SUBJECT: Waldorf School site plan application

Report Number: PB-66-19

The purpose of this report is to recommend conditional approval of the undelegated site plan application for the proposed Halton Waldorf High School located at 2254 Orchard Road. The following objectives of Burlington's Strategic Plan apply to this application:

DATE: Tuesday, September 17, 2019
APPLICATION NAME: 2254 Orchard Road - Halton Waldorf School
ADDRESS: 2254 Orchard Rd.
FILE: 535-002/19

endix B – Site Plan

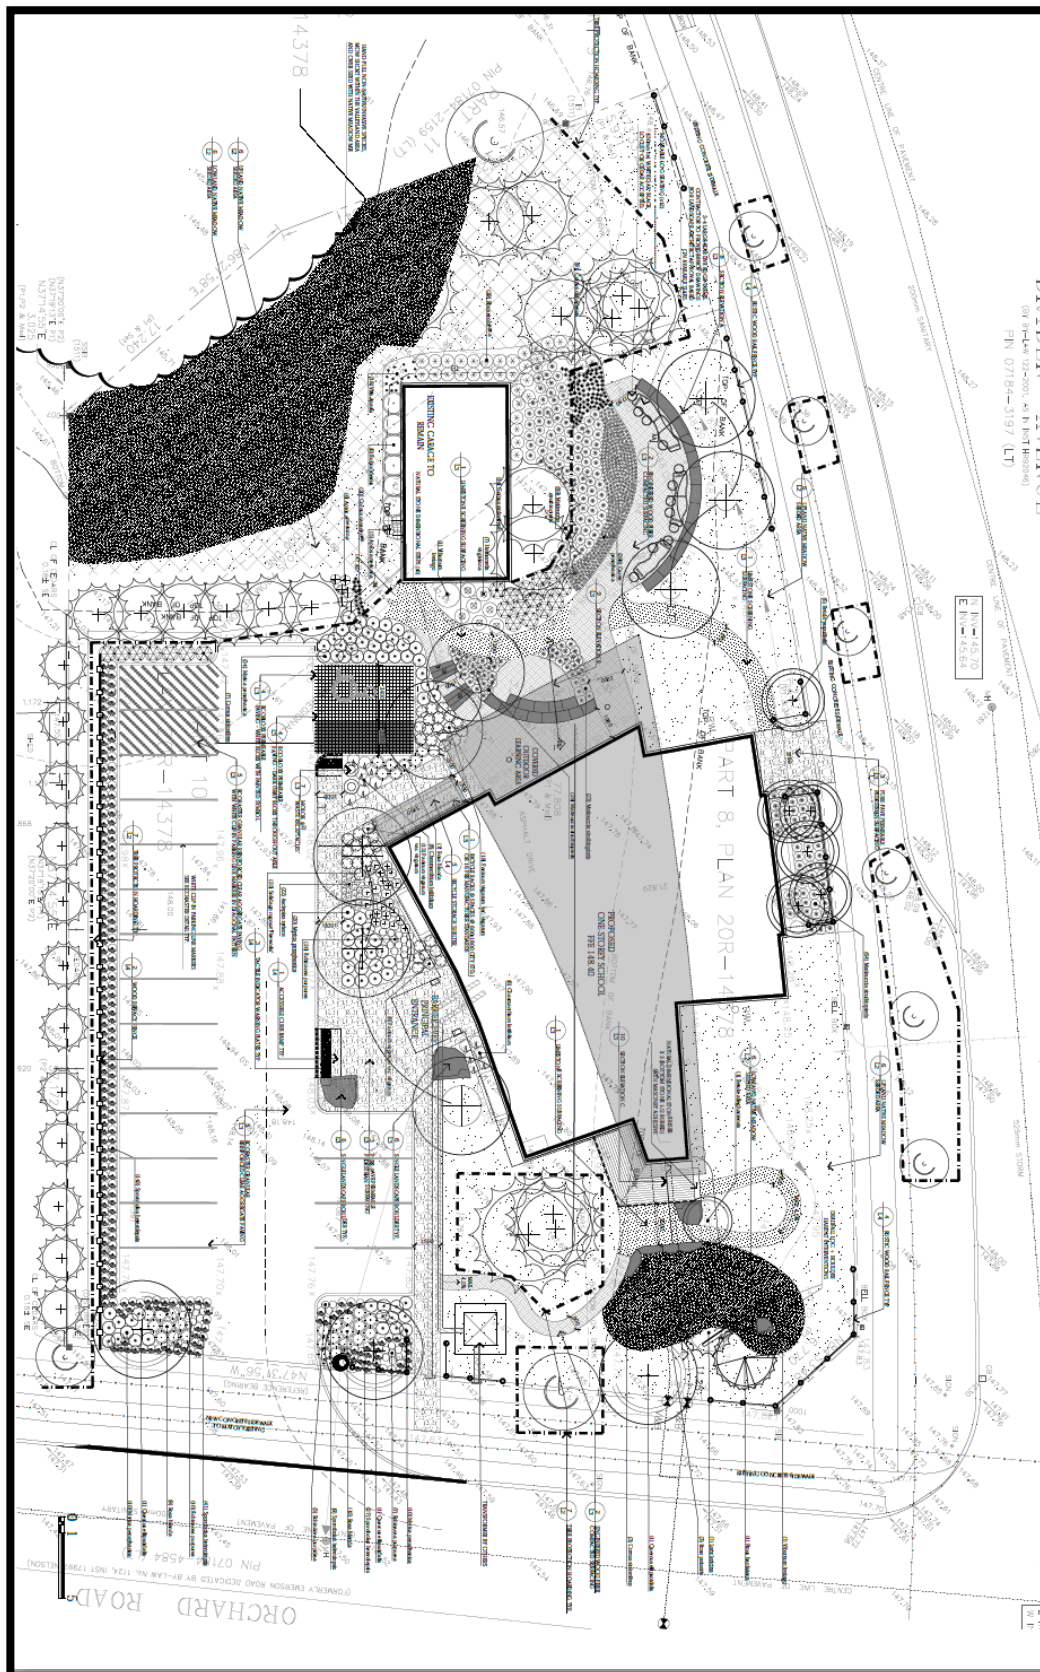
It should be noted that the proposed site plan shows future 1 storey additions to the school building. These additions are not included in this site plan application and do not form part of this recommendation for site plan approval. Additional planning approvals will be required should the school wish to proceed with these additions.

- 3.1. Applicant has indicated that the window well along Dryden Avenue will not be attached to the building. Applicant to provide details as well as, modify the basement floor plan as it suggests that the window well is part of the foundation and not unattached.
- 3.2. Apply for a Zoning / Grading and Drainage Clearance Certificate.
- 3.3. Submit a completed Non-residential Development Charges Information Form.
